MONTGOMERY COLLEGE - OFFICE OF PROCUREMENT
MACKLIN TOWER MBI FINANCE LAB SUITE 100, ROCKVILLE CAMPUS
RFP NO.: 620-011
RFP CLOSING DATE AND TIME: APRIL 7, 2020 @ 3:00 PM

ADDENDUM #1
Issued: March 27, 2020

Project:	MC RV MT MBI FINANCE LAB SUITE 100 RENOVATIONS	Date:	03/25/2020
		Reference:	
Title:	Addendum #1 Drawing Narrative	BKM Project No:	19106.01

SHEET TITLE: LIFE SAFETY PLANS

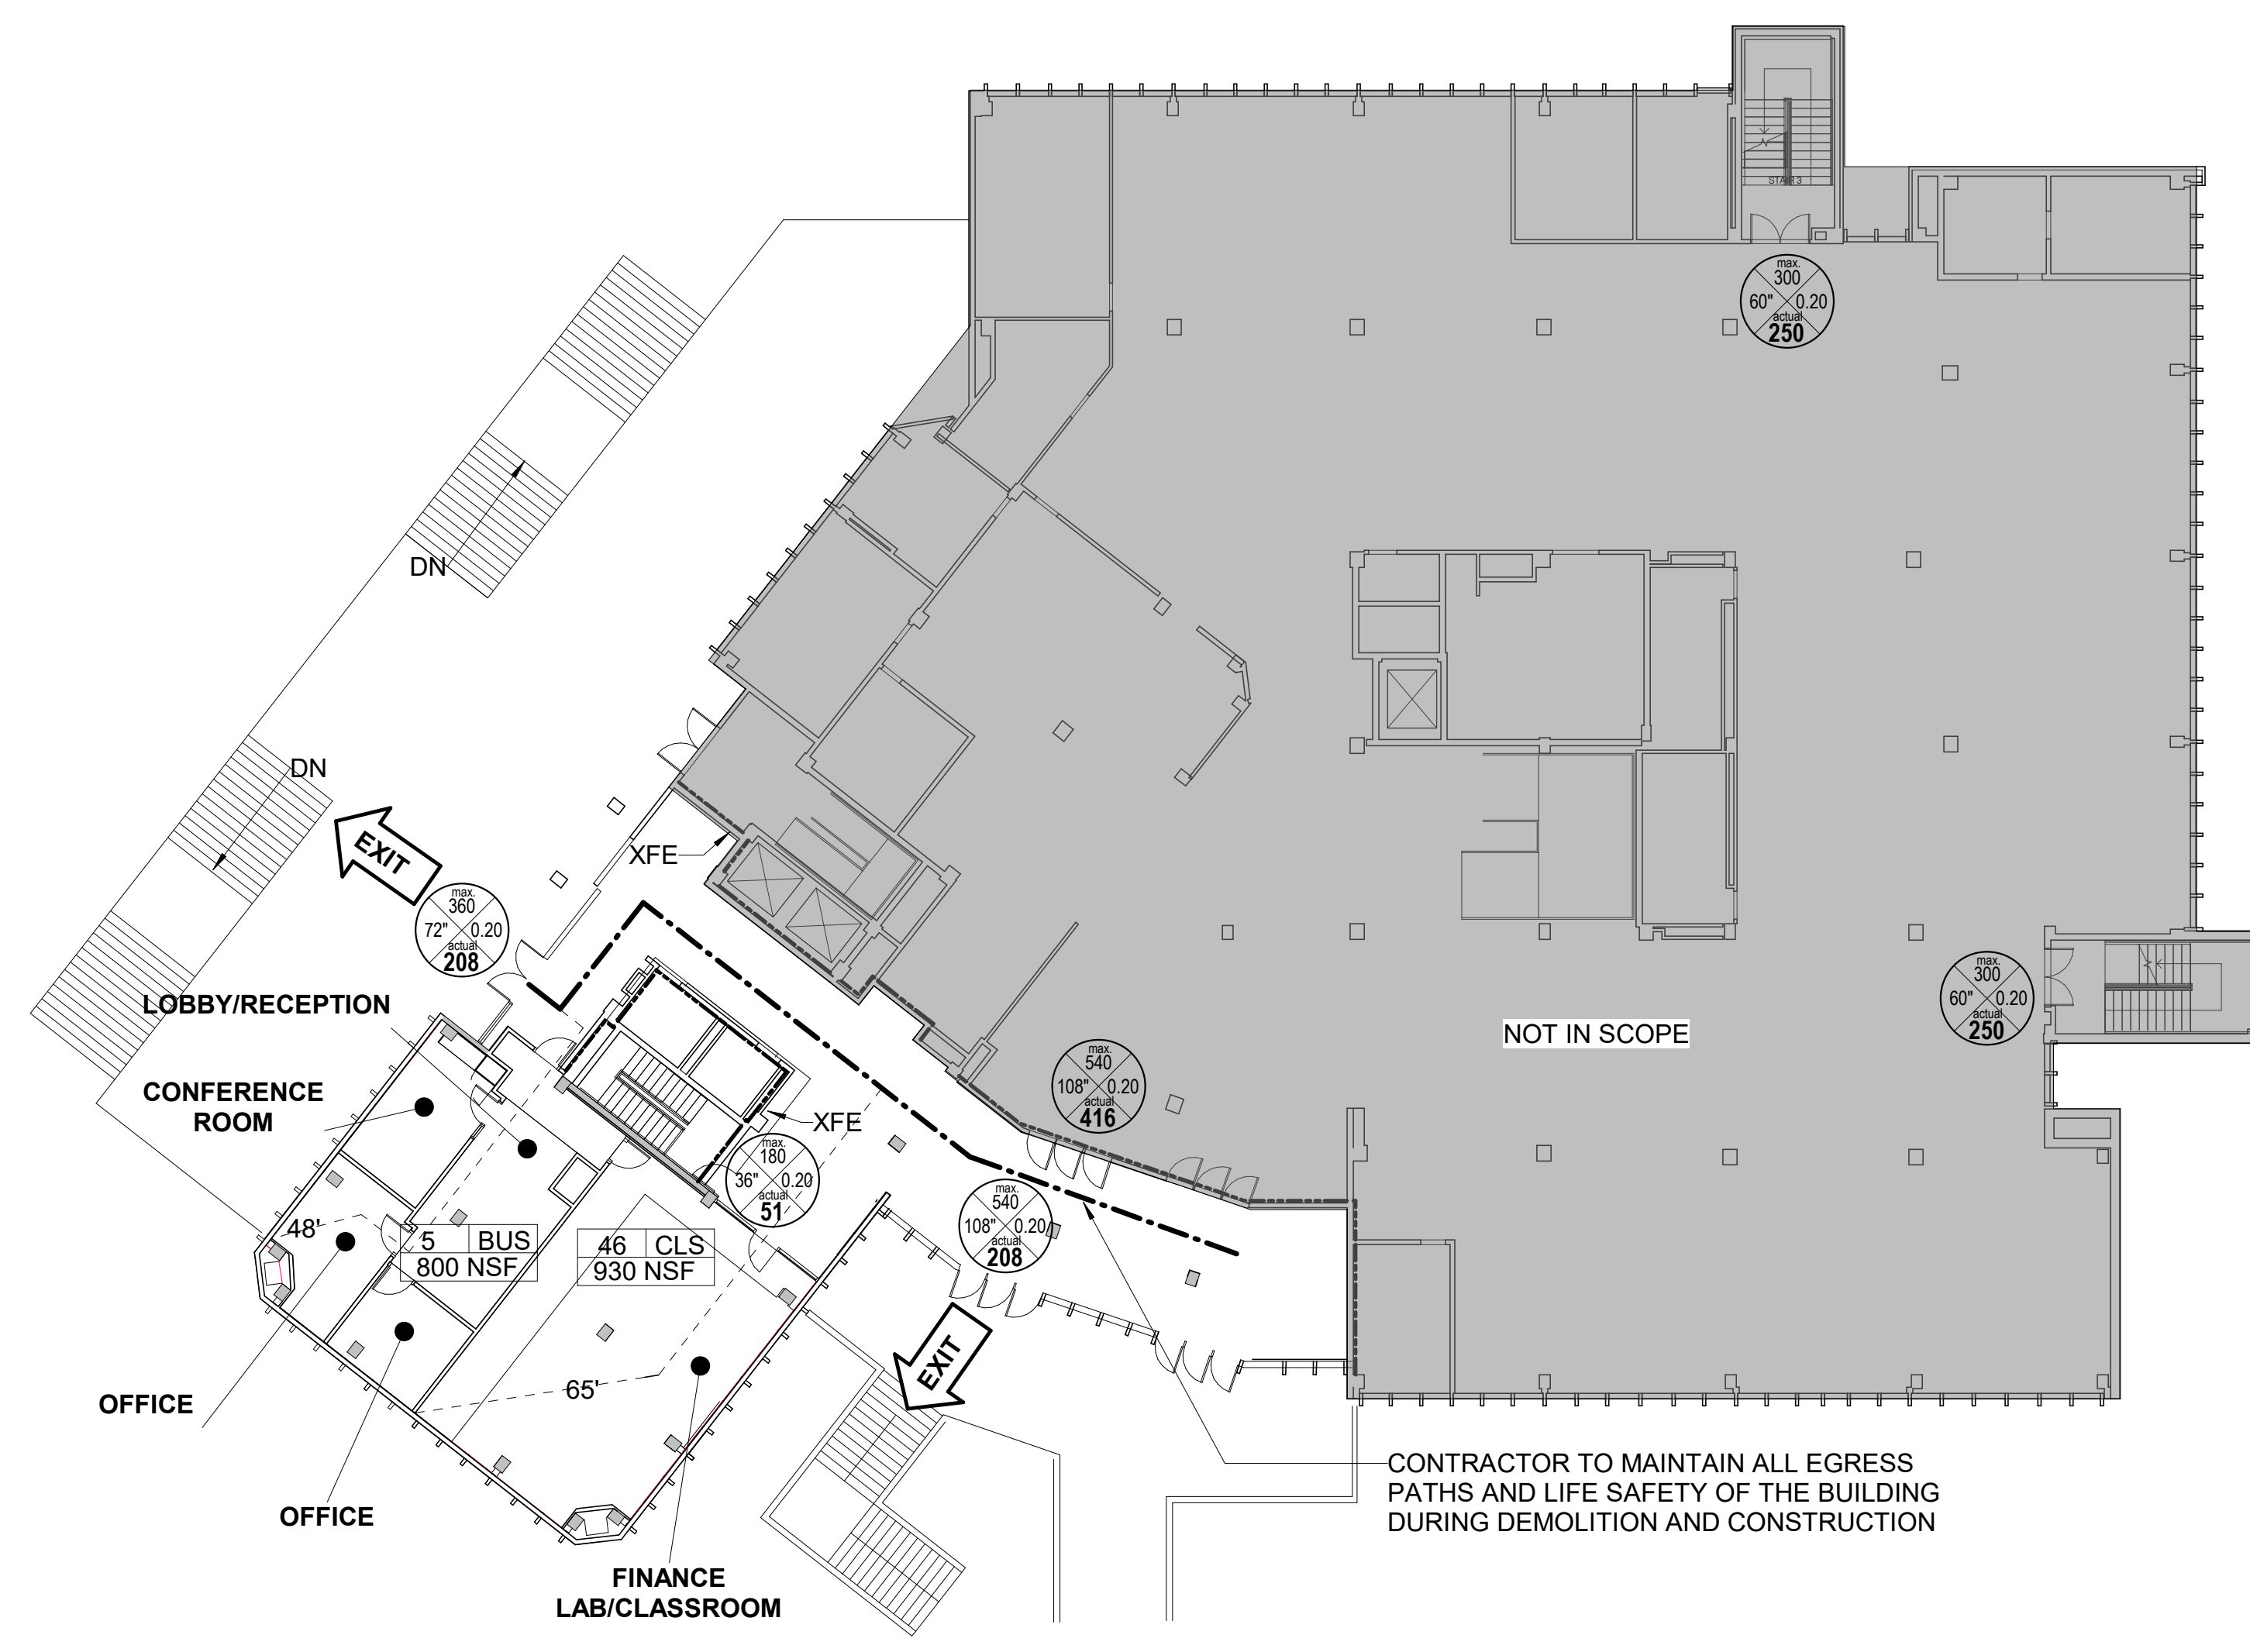
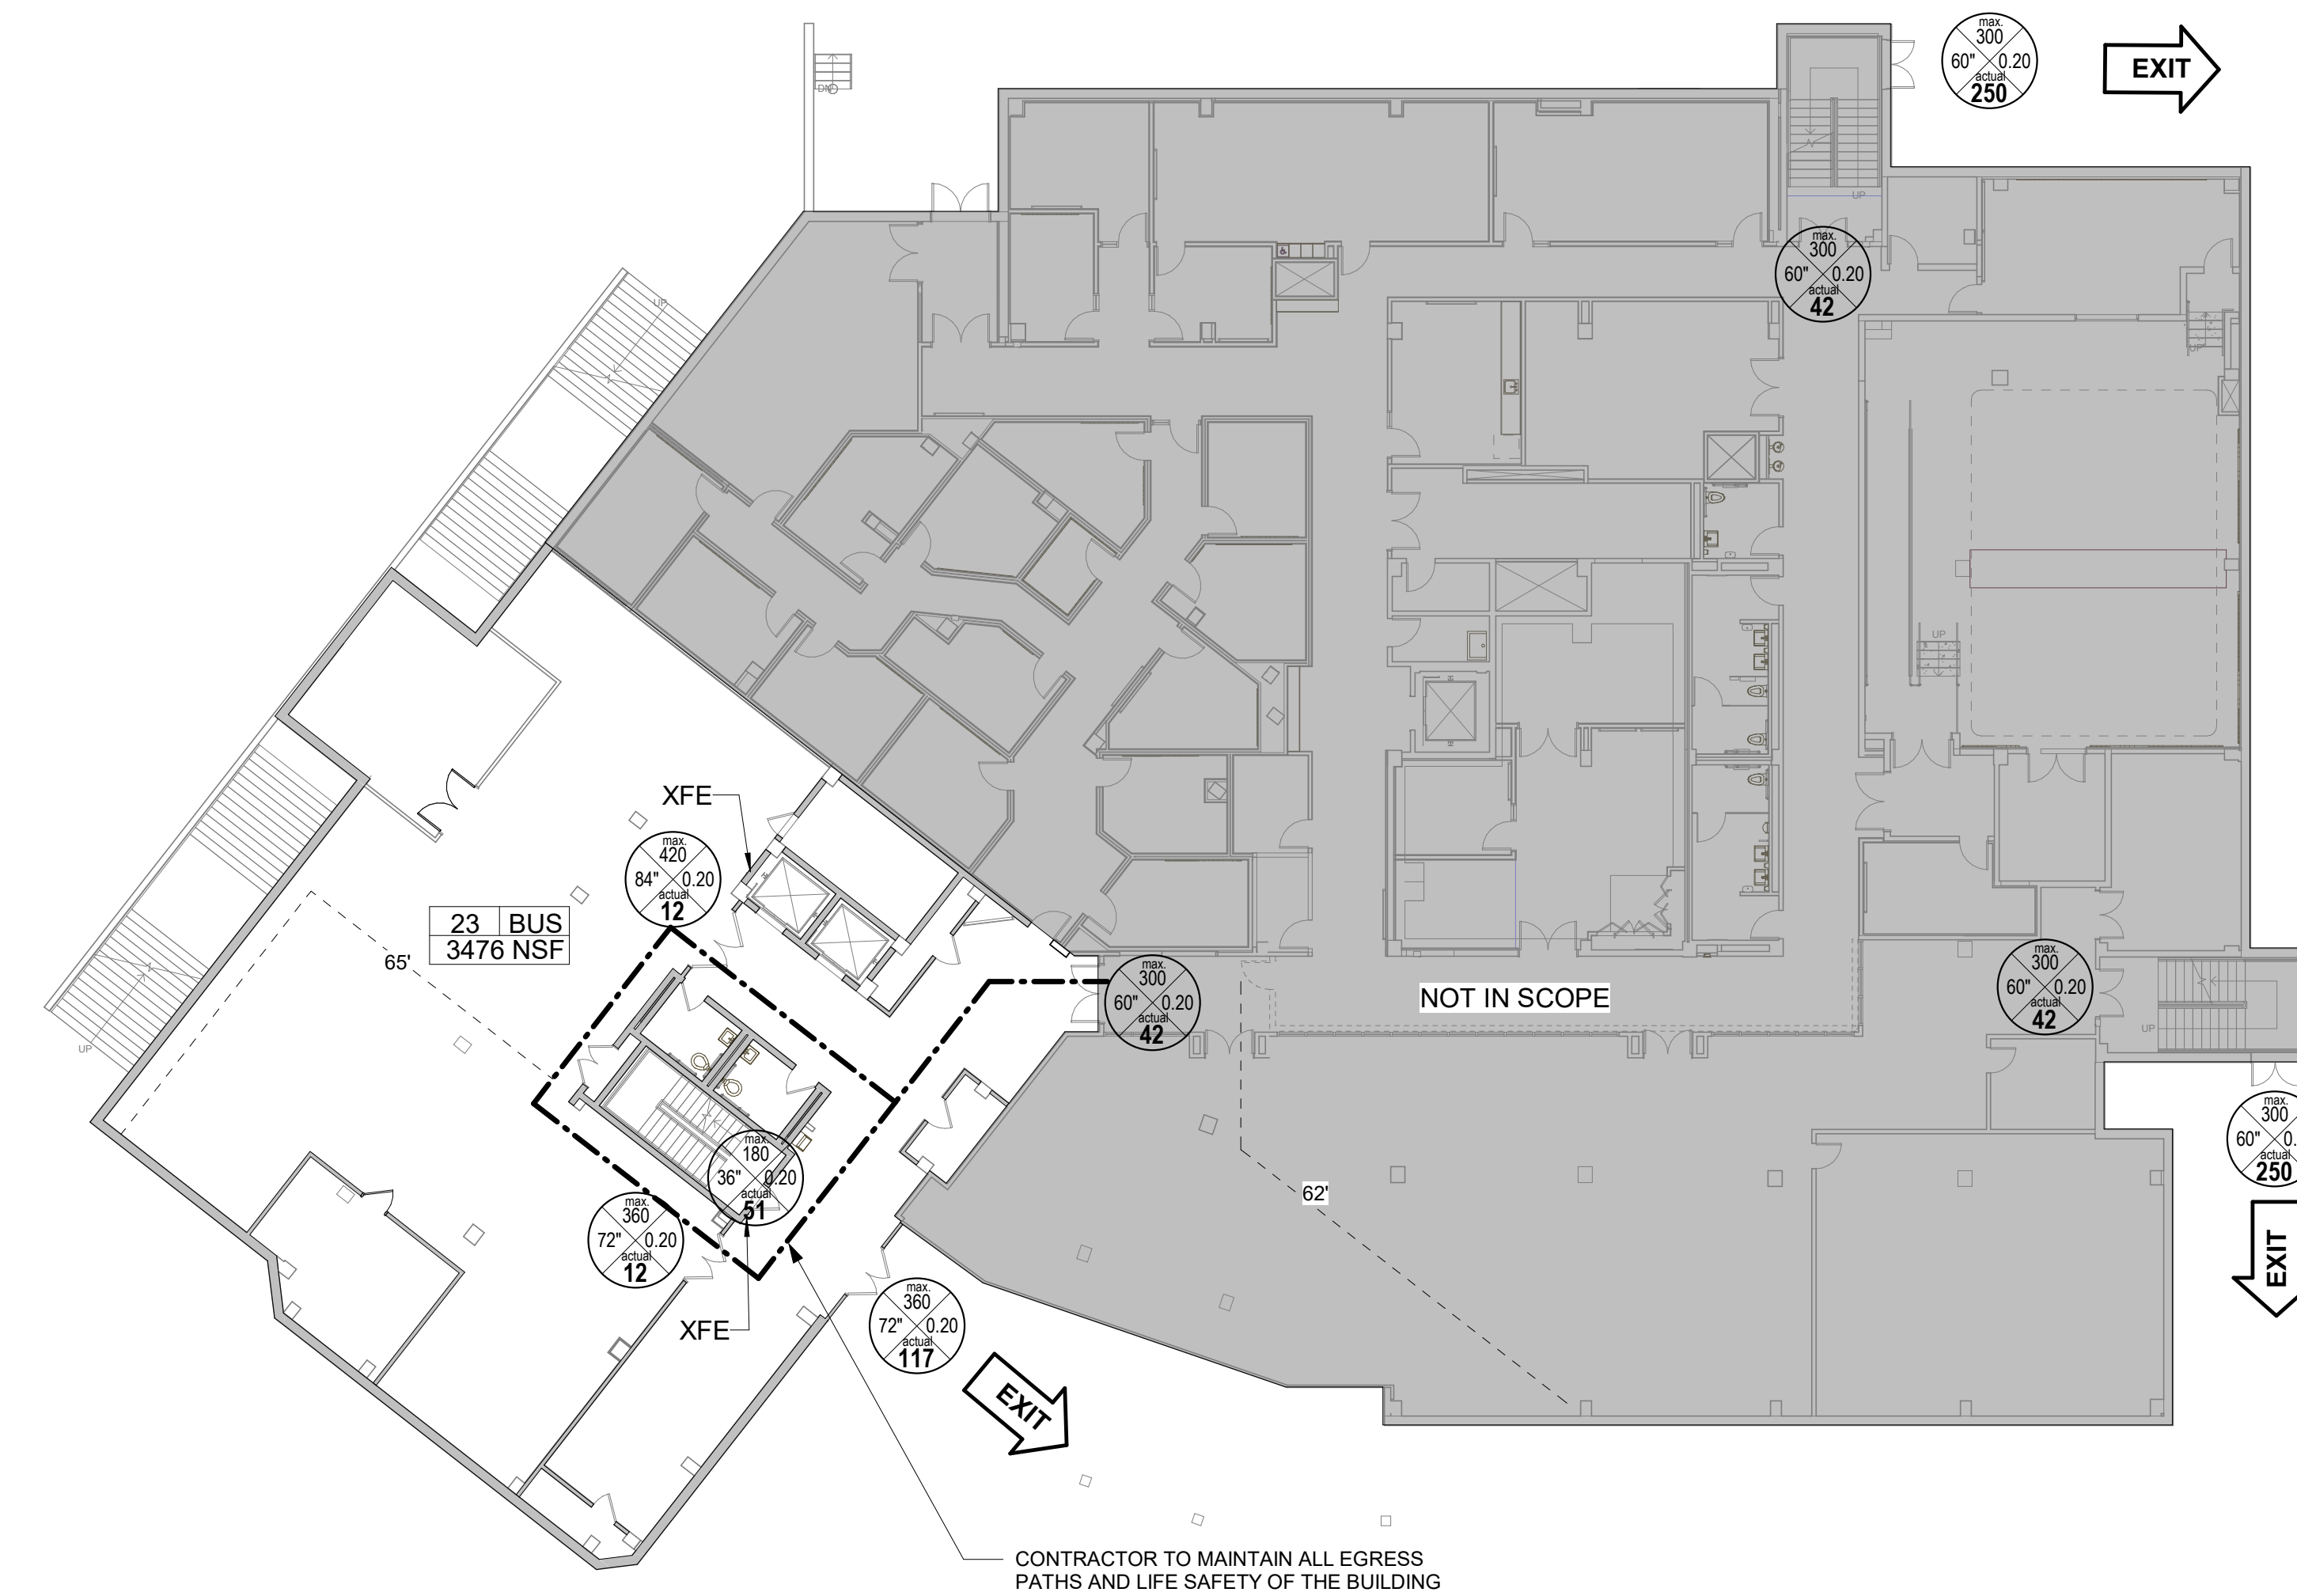
G0.11 – Life Safety Plans

- The building height has been corrected to reflect the height from fire vehicle access to top occupiable floor.
- Notes regarding fire protections systems throughout the building have been revised.
